## **Highway Officer – Response 1**

### **Highway Holding Objection.**

### **Site and Situation**

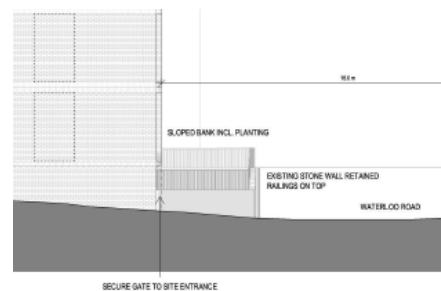
Given the Fire Escape egress point, and the secure gate to the communal garden form the parking area (see query below) at the top of the ramp is it is presumed that this is.

The ramp, with a 1:14 gradient, is not compliant for vehicles or pedestrians and there is no footpath or protected walkway for pedestrian/vulnerable users.

The gate detail in terms of effective width of the access opening is not forthcoming and therefore the ability of vehicles to pass on the ramp has not been demonstrated.

If only one vehicle is able to utilise the ramp at a same time there are safety concerns should accessing and egressing vehicles coincide; with either an excessively long reverse up a steep slope or backing out to Waterloo Road with the Speakman Rd junction opposite required.

Tracking for the largest vehicle likely to utilise this access is required, as well as tracking of the above mentioned manoeuvres i.e. passing on the ramp or otherwise.

Gate detail to understand effective width is also required.

Whilst historic (2009) the snippet above also demonstrated that the visibility splay information is not accurate.

The pillar to the existing house about the access will be within the 0.6m to 2m visibility envelope and, although described as a low wall and railing, as can be seen from the second snippet from DWG No. 1351 Rev B, Proposed Elevations this side of the access would have obstructed sightlines.

Moreover, the visibility splay “y” distance is required to be 25m, not 20m, for a 20mph street, see MfS Table 7.1. However, this street is subject to a 30mph speed limit and therefore 43m is the required distance.

Further, as can be seen from the Streetview snippet that cars parked adjacent to the entrance will further undermine visibility and therefore parking restriction, i.e. a TRO and signing/lining would be required to be sought (with public consultation part of the process), at the applicant's expense, to protect highway users' safety.
